Drawing Title: ELECTRICAL 3RD, 4TH AND 10TH FLOOR POWER ONE LINE SCHEMATIC AND RISER DIAGRAM

Project Title: RENOVATE FOR CLINICAL IMPROVEMENTS

Project Number: 583C16254
Building Number: 1
Drawing Number: EP-600
3FY12

2 MH403 ENLARGED MECHANICAL ROOM PLAN
SCALE: 1/2" = 1'-0"

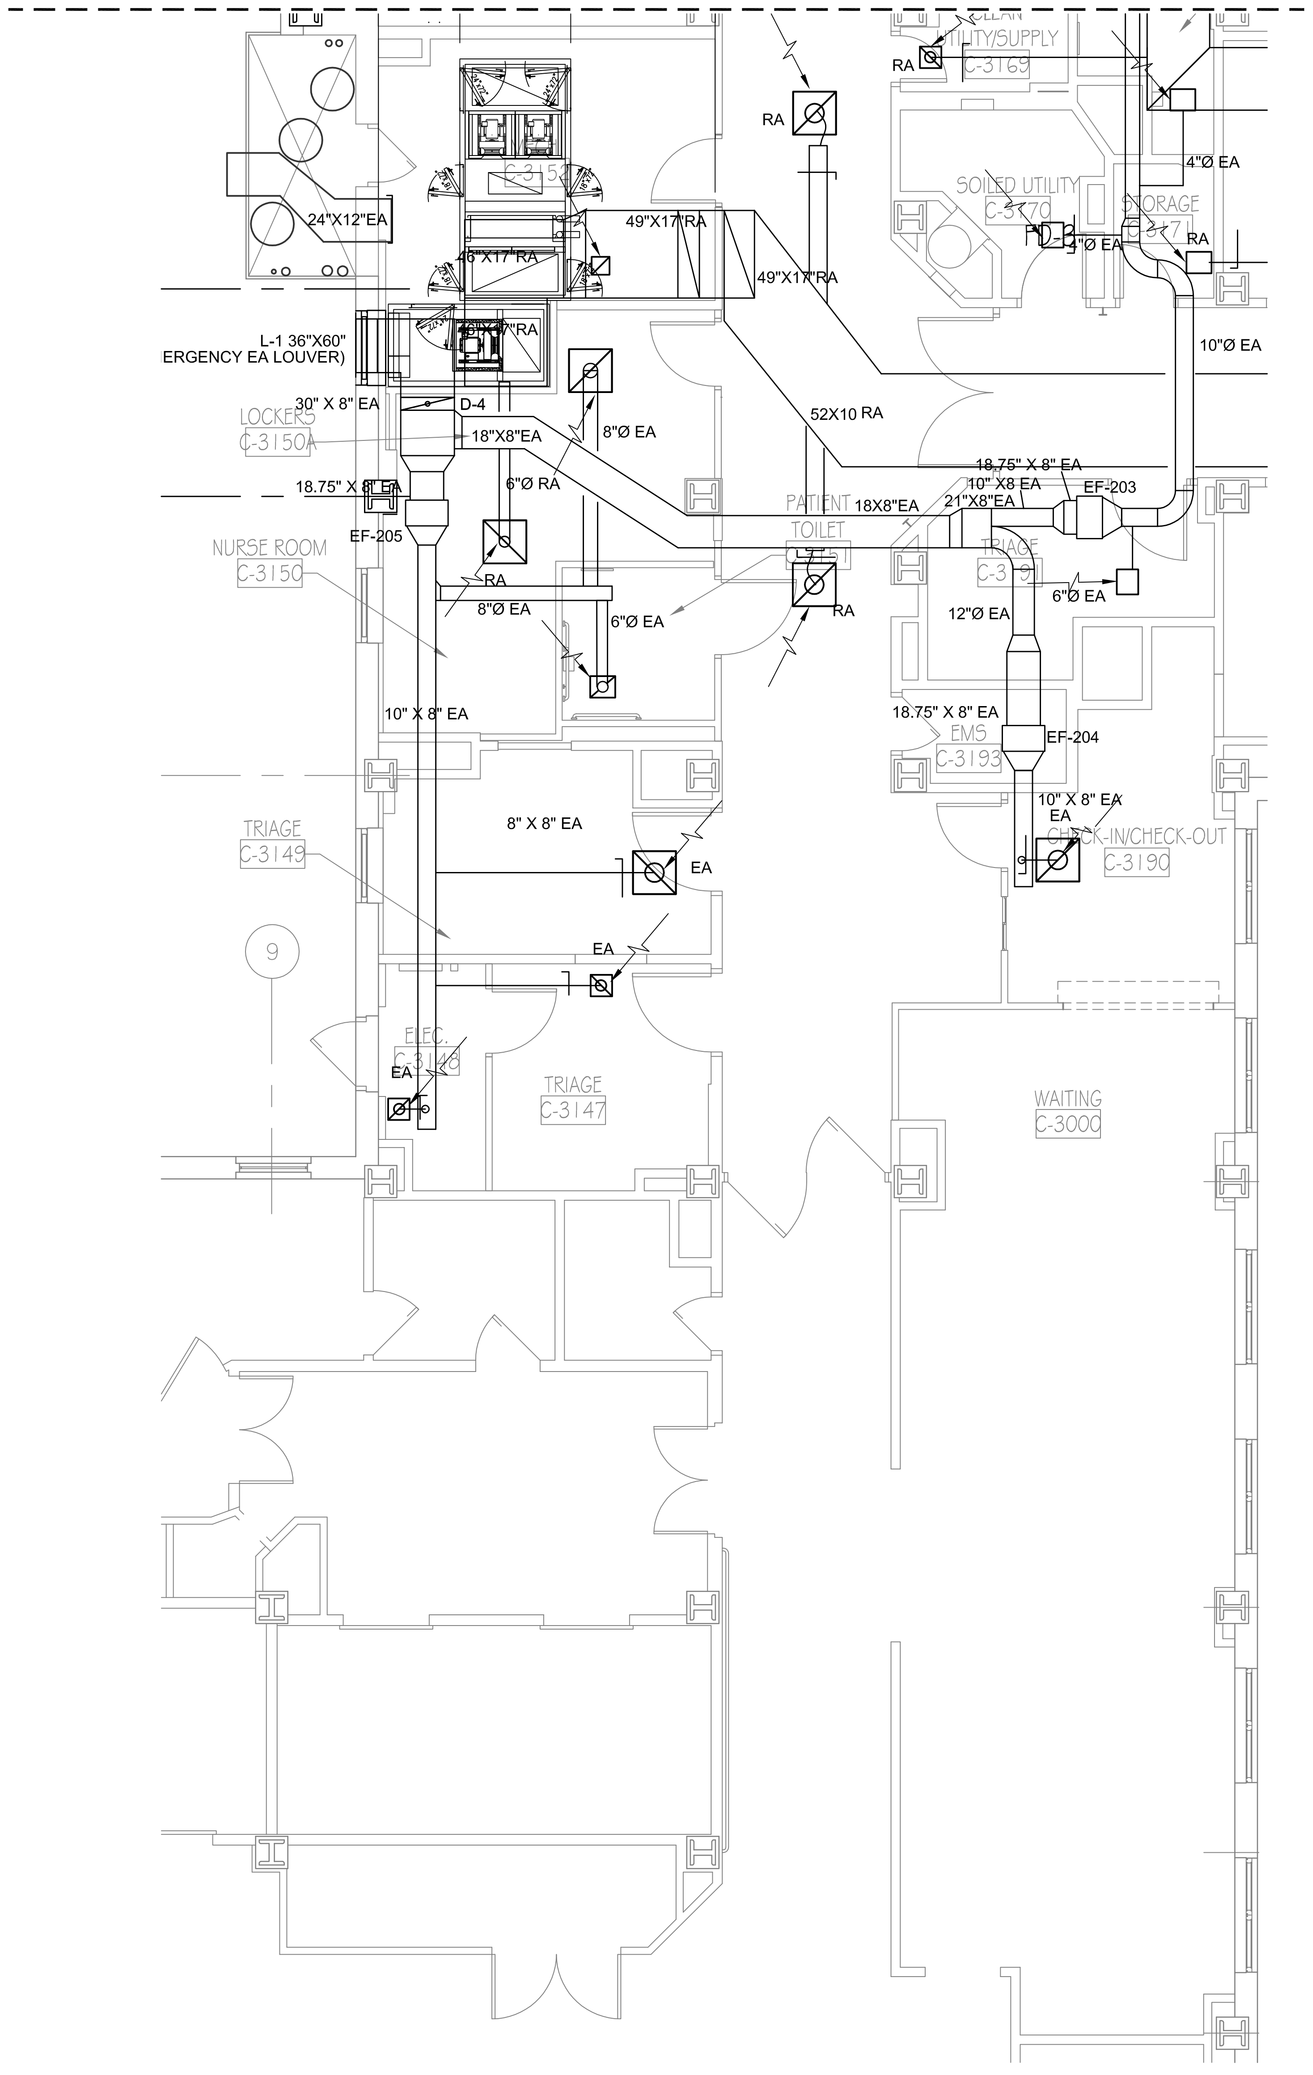
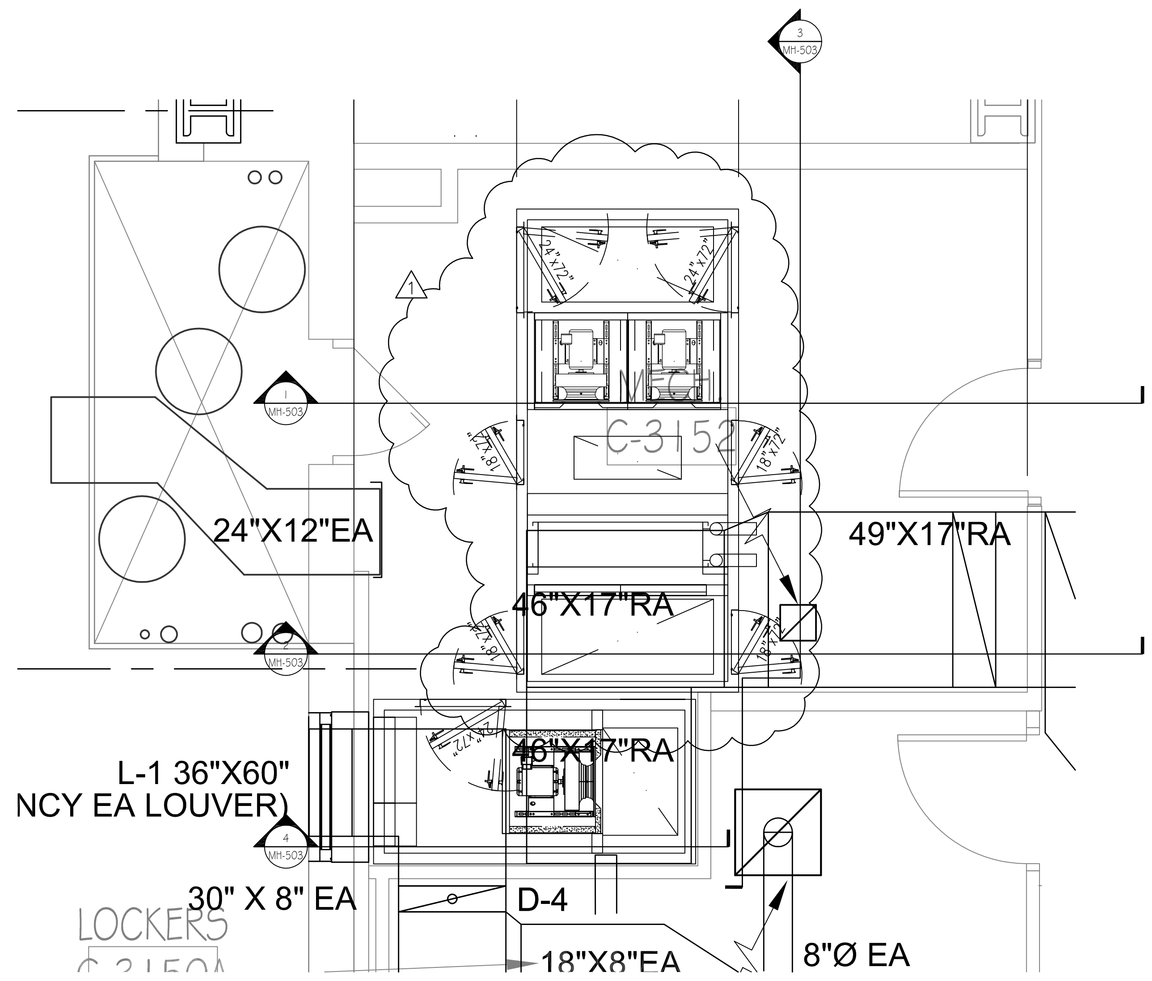
1. THE DRAWING ARRANGEMENT SHOWN IN DETAIL 2 SUPERSIDES ARRANGEMENTS SHOWN ELSEWHERE IN OTHER DRAWING PLAN ARRANGEMENTS(OVERALL AND MECHANICAL PLUMBING). THOSE SHOULD BE USE FOR REFERENCE ONLY. CHANGES SHOWN TO AHU-58 PERTAIN TO THE ARRANGEMENT OF THE AIR HANDLING UNIT SECTIONS AND INCLUDE AN OUTSIDE AIR CONNECTION TO THE UNIT.

ENLARGED MECHANICAL ROOM PLAN (2 / MH405) SCALE: 1/2" = 1'-0"

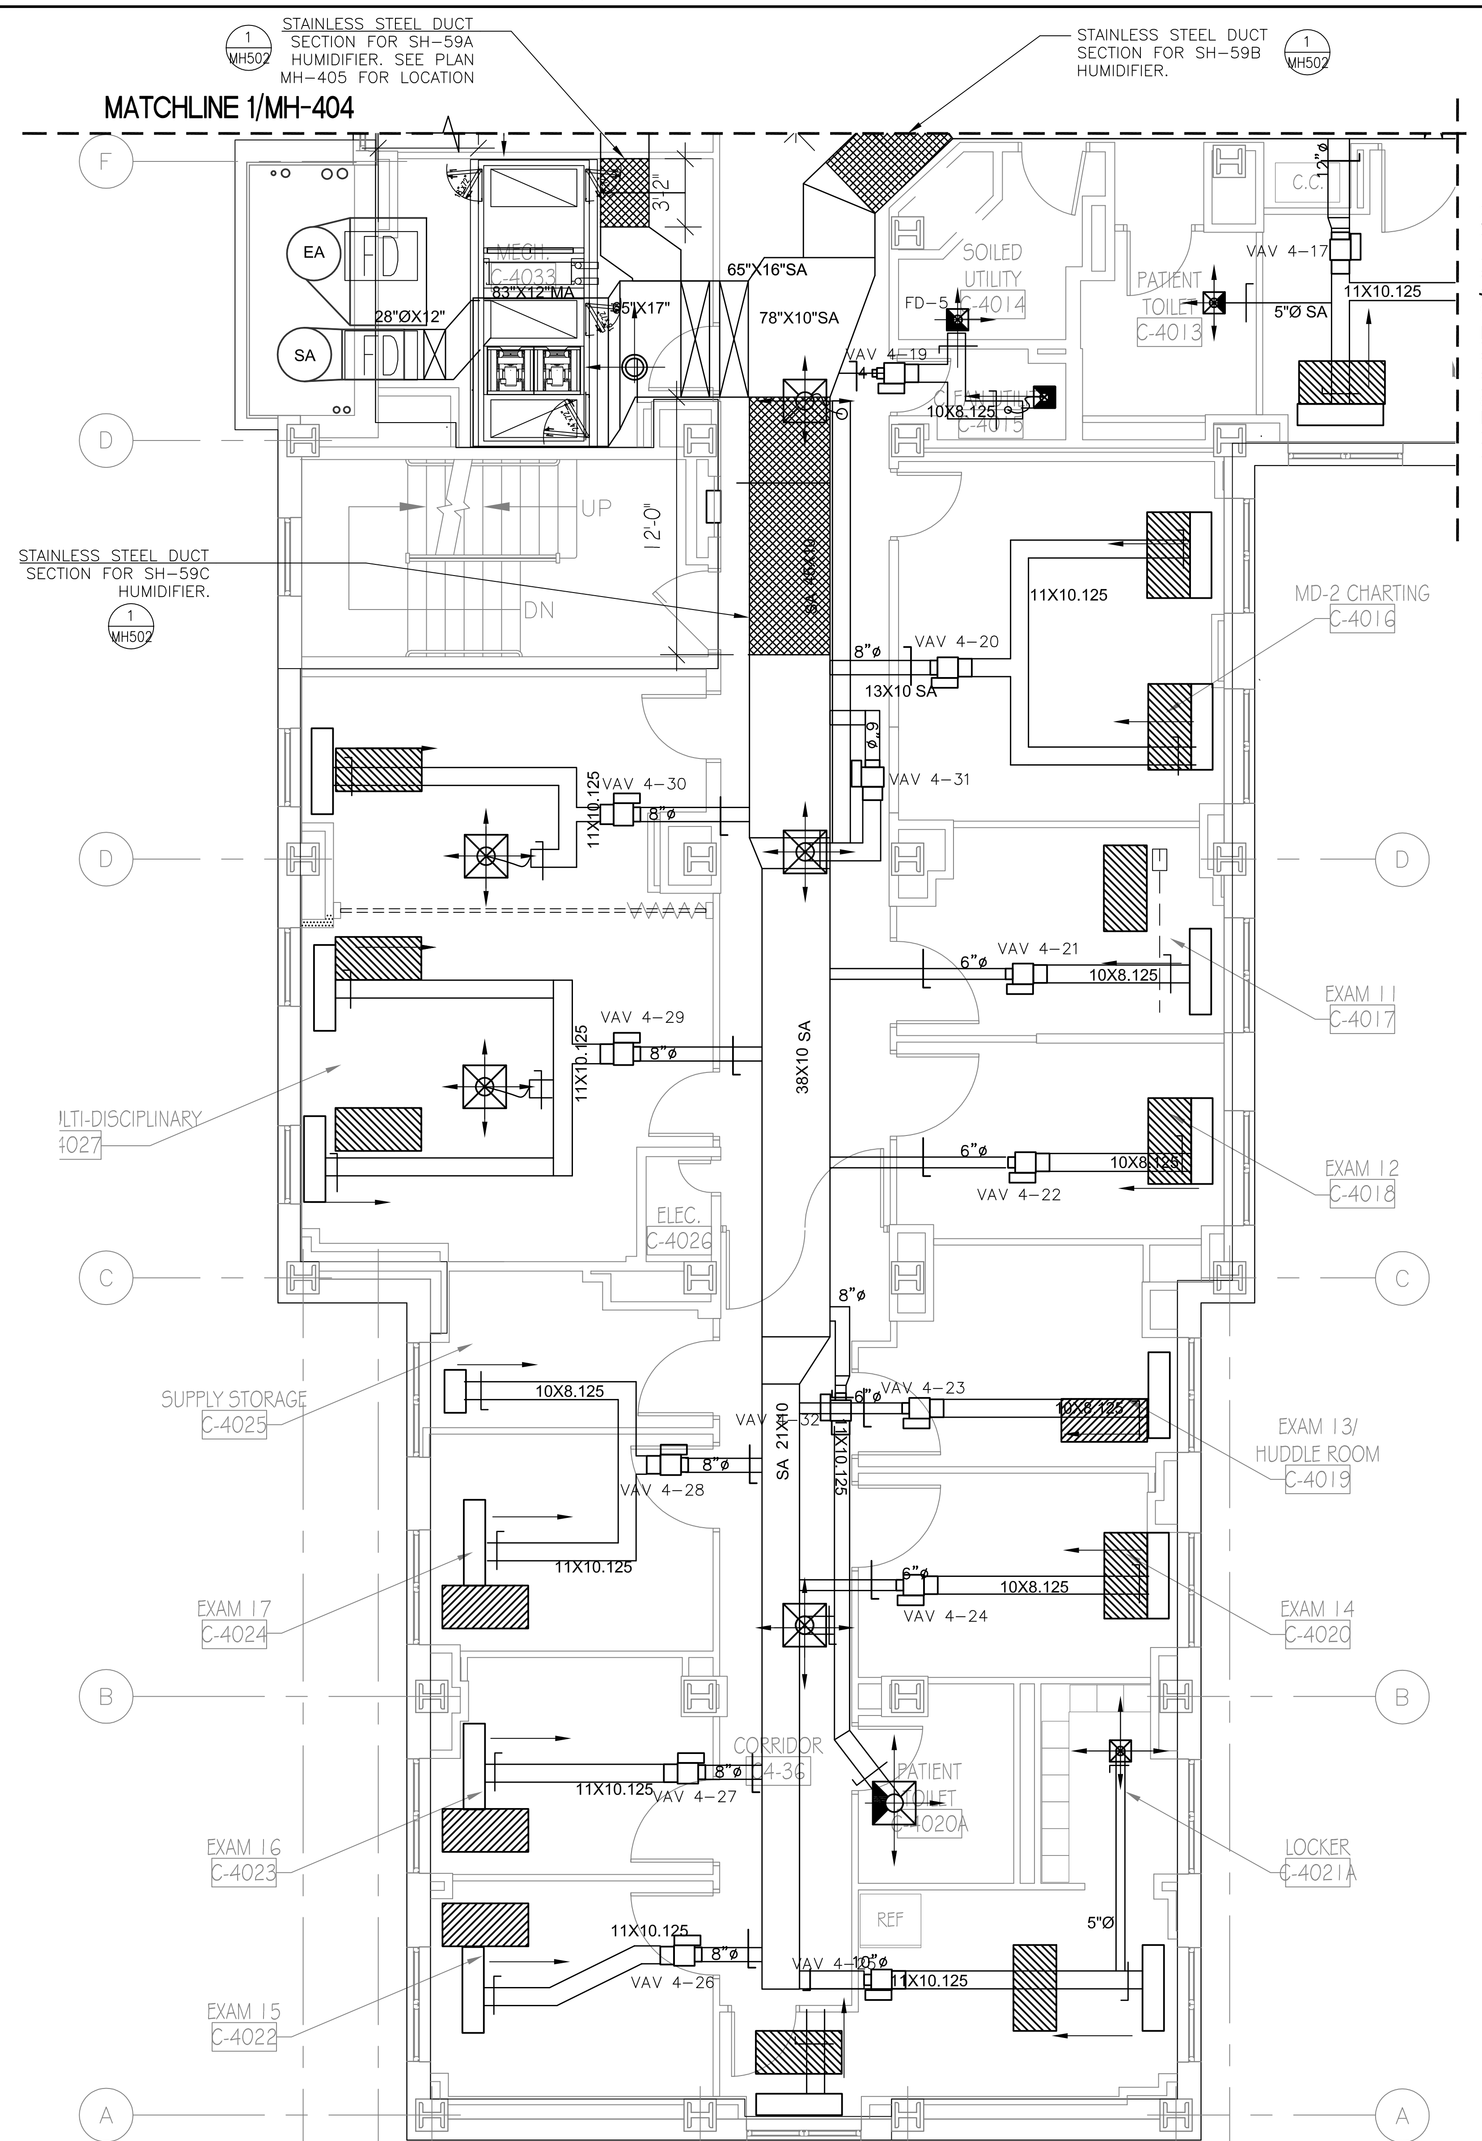
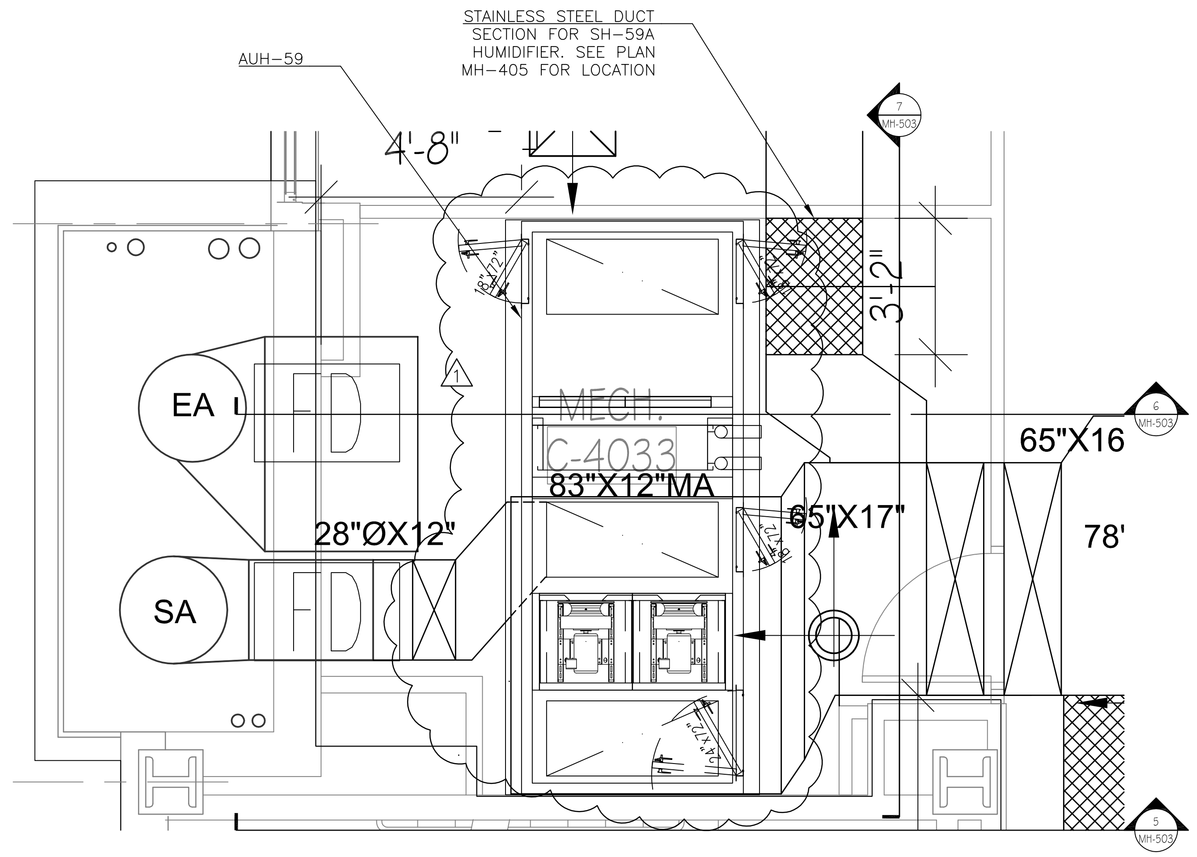
1. THE DRAWING ARRANGEMENT SHOWN IN DETAIL 2 SUPERSIDES ARRANGEMENTS SHOWN ELSEWHERE IN OTHER DRAWING PLAN ARRANGEMENTS(OVERALL AND MECHANICAL PLUMBING). THOSE SHOULD BE USE FOR REFERENCE ONLY. CHANGES SHOWN TO AHU-59 PERTAIN TO THE ARRANGEMENT OF THE AIR HANDLING UNIT SECTIONS AND INCLUDE AN OUTSIDE AIR CONNECTION TO THE UNIT.
